APPENDIX J.1: CEQA VMT Analysis

City of Los Angeles Department of Transportation (LADOT) Interdepartmental Correspondence Re: Updated Transportation Impact Assessment For The Proposed Mixed-Use Project At 1123 – 1161 South Main Street (ENV-2018-7379-EAF/VTT-82463/ZA-2018-7378-ZV-TDR-SPR), DOT Case No. CEN18-47813, December 19, 2019.

1123 – 1161 S Main St DOT Case No. CEN18-47813

Subject: UPDATED TRANSPORTATION IMPACT ASSESSMENT FOR THE PROPOSED MIXED-USE

CONCEPTUAL PROJECT SITE PLAN

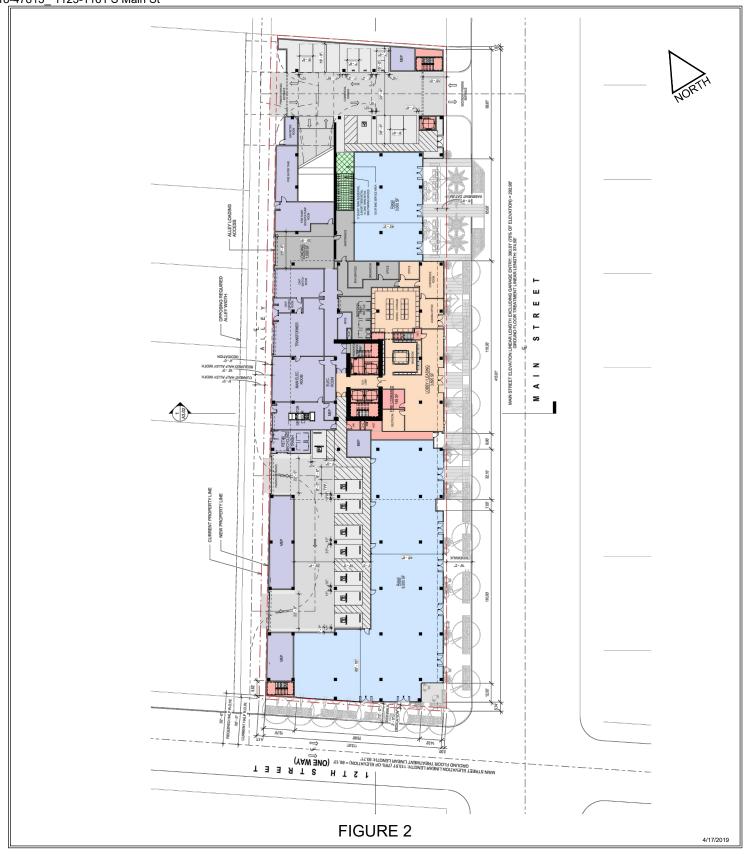
The conceptual site plan for the project (see **Attachment A**) is acceptable to DOT. However, the review of this study does not constitute approval of the dimensions for any new proposed driveway. This requires separate review and approval and should be coordinated with DOT's Citywide Planning Coordination Section (201 North Figueroa Street, 5th Floor, Room 550, at 213-482-7024). In order to minimize and prevent last minute building design changes, the applicant should contact DOT for driveway width and internal circulation requirements prior to the commencement of building or parking layout design.
